UNITED STATES PATENT AND TRADEMARK OFFICE

APPLICATION NO.	FILING DATE	FIRST NAMED INVENTOR	ATTORNEY DOCKET NO.	CONFIRMATION NO.
10/790,217	03/02/2004	Akira Yoneoka	P21-163407M/NY	9855

DETAILED ACTION

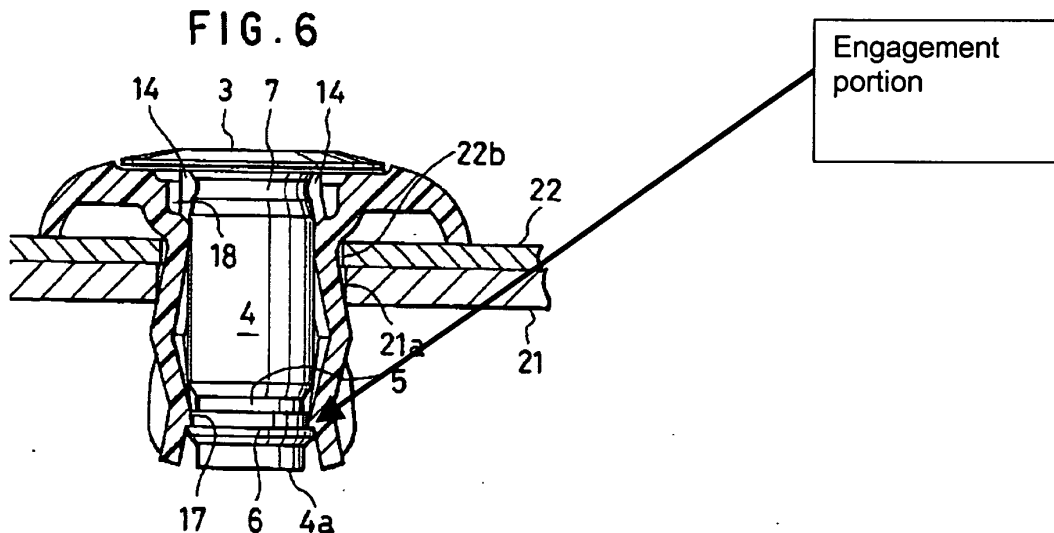
- A flange 10
- An openable leg 11
- An insertion hole 8
- An engagement portion (see arrow in Fig 6 below) at the inner surface of the leg portion

- A head portion 3
- An insertable shaft portion 4 with engagement surface 6 (vertical and angled edge) and a lock surface 6 (vertical upper face) are formed at the shaft portion 4.

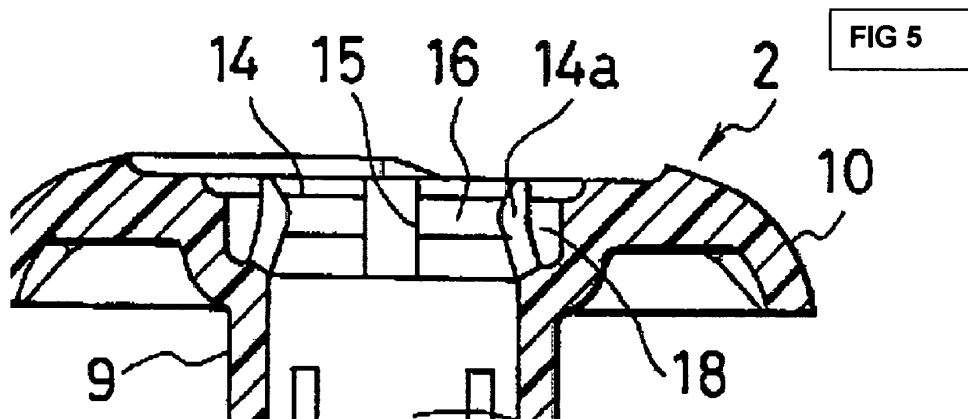
→ **Further Re claim 9 and claim 4:** Wherein the grommet flange comprises: (note the

3 levels of the hole in the flange generally shown in the figure below.

- A large diameter hole portion (uppermost large-diameter hole, pin head rests in)
- An engagement hole (assumed hole extending axially below large diameter hole portion, at level of 14 in Figure 5 above)
- An extending portion (at level of 18 in Figure 5 above) forming a pin-hole portion of smaller diameter than large diameter portion
